SUNDRY NOTICES AND REPORTS ON WELLS
Do not use this form for proposals to drill or to re-enter an abandoned well. Use form 3160-3 (APD) for such proposals.

8: Well Name and No.
WILDER FEDERAL AC 28 4H

2. Name of Operator
CONOCOPHILLIPS COMPANY

9: API Well No.
30-025-40502-00-X1

WILDER FEDERAL AC 28 4H

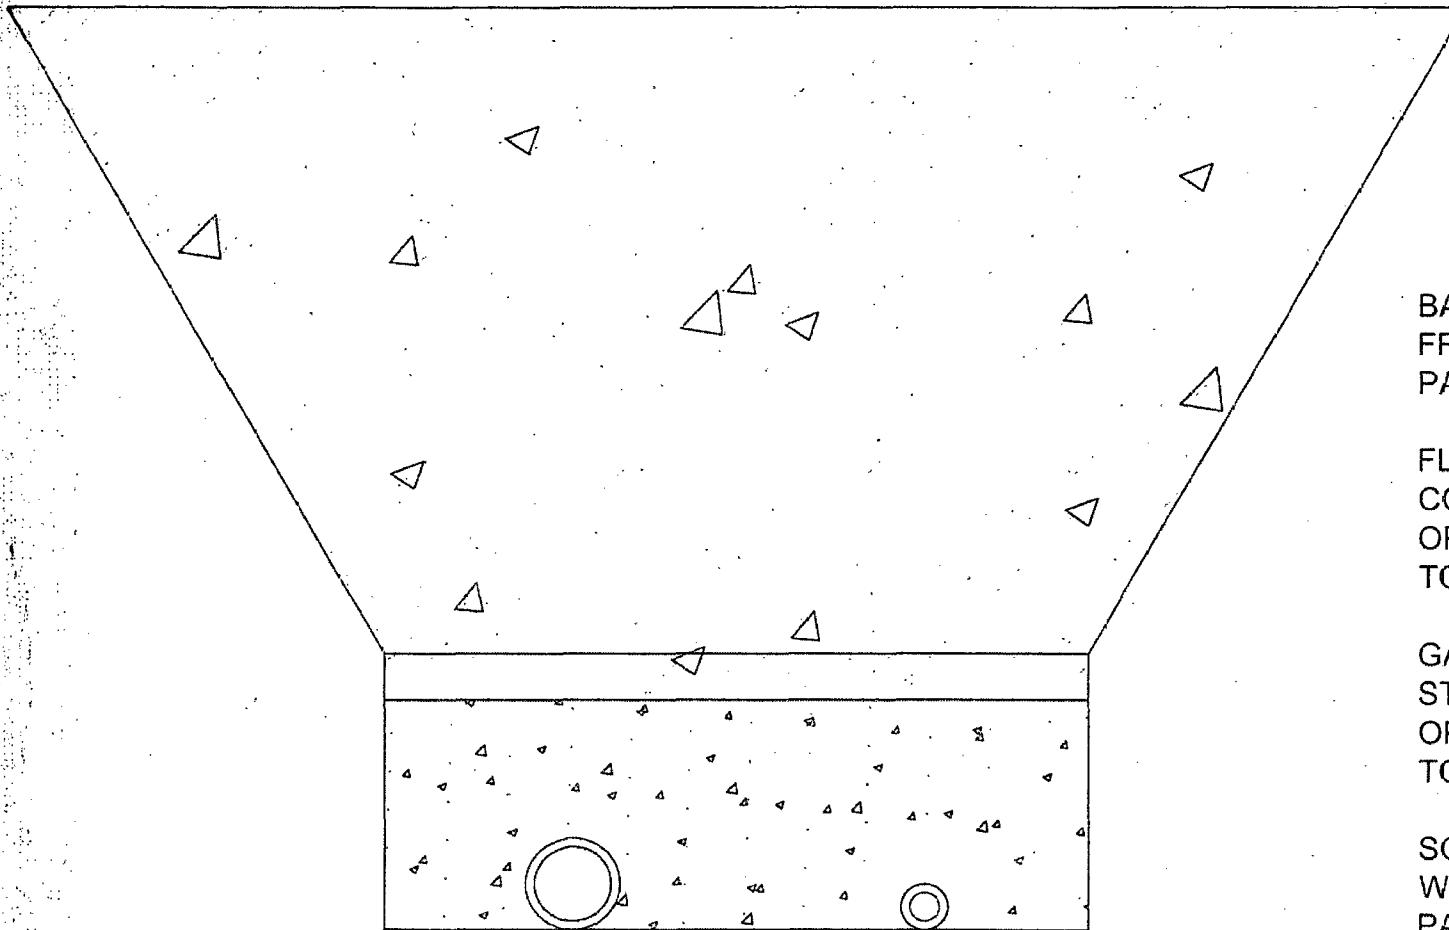
ConocoPhillips Company respectfully requests to amend the method of installation as it pertains to the products line from surface to buried. The route for the pipeline has not changed. The line will be 4" Steel, operated at up to 1480# psi from the well to the Wilder Central Tank Battery. All activity will be kept in the utility corridor already authorized under the APD.

We also request to install a buried 2" Steel gas supply line operated at up to 1100# psi from the well to the Wilder Central Tank Battery. All activity will be kept in the utility corridor already authorized under the APD.

governing separation between buried lines and roadways. We request the ROW width be amended to 30' permanent with 20' construction workspace.

BACKFILL DIRT TO BE AS
FREE OF ROCKS AND LARGE
PARTICLES AS POSSIBLE

FLOW LINE WILL BE 4"
COATED STEEL PIPE w/ AN
OPERATING PRESSURE UP
TO 1480# PSI.

GAS SUPPLY LINE WILL BE 2"
STEEL PIPE w/ AN
OPERATING PRESSURE UP
TO 1100# PSI.

SOFT FILL DIRT OR SAND
WITH NO ROCKS OR SOLID
PARTICLES GREATER THAN
1" IN CIRCUMFERENCE
